**Before the  
CONSUMER PRODUCT SAFETY COMMISSION  
Bethesda, MD 20814**

In the Matter of )  
 )  
Safety Standard and Notification )  
Requirements for Button Cell or Coin ) Docket No. 2023-0004  
Batteries and Consumer Products )  
Containing Such Batteries )

**COMMENTS OF THE  
CONSUMER TECHNOLOGY ASSOCIATION**

Figure 2: Button/coin cell battery symbols

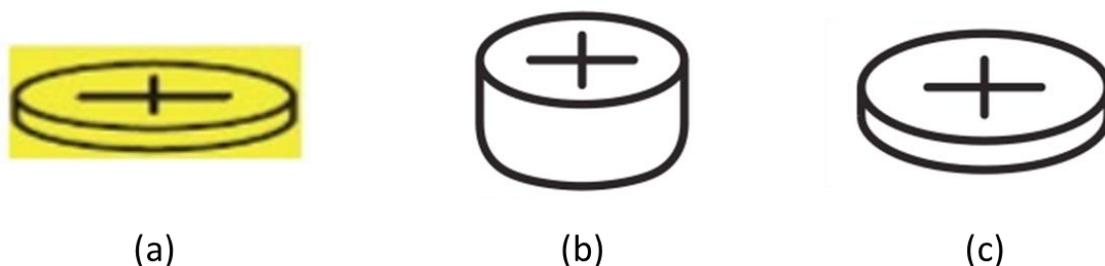
CTA appreciates CPSC’s efforts to use internationally recognized symbols in its required warnings. However, the icon CPSC proposes to represent a “button cell or coin battery”<sup>74</sup> does not match the international symbol for a button cell battery, or the international symbol for a coin cell battery.

Figure 2 (a) shows the proposed CPSC symbol for button and coin cell batteries. Figure 2 (b) shows the ISO 7000 / IEC 60417 symbol for a button cell battery,<sup>75</sup> and Figure 2 (c) shows the ISO 7000 / IEC 60417 symbol for a coin cell battery.<sup>76</sup> The proposed CPSC symbol includes

color while the internationally accepted symbols do not. The proposed CPSC symbol has a different aspect ratio and is rotated farther on the x axis than the internationally accepted symbols for coin and button cell batteries. To avoid consumer confusion CPSC's symbols should match internationally recognized symbols. To ensure its symbols match internationally recognized symbols CPSC should reference symbols from international standards instead of publishing symbols in its regulations.
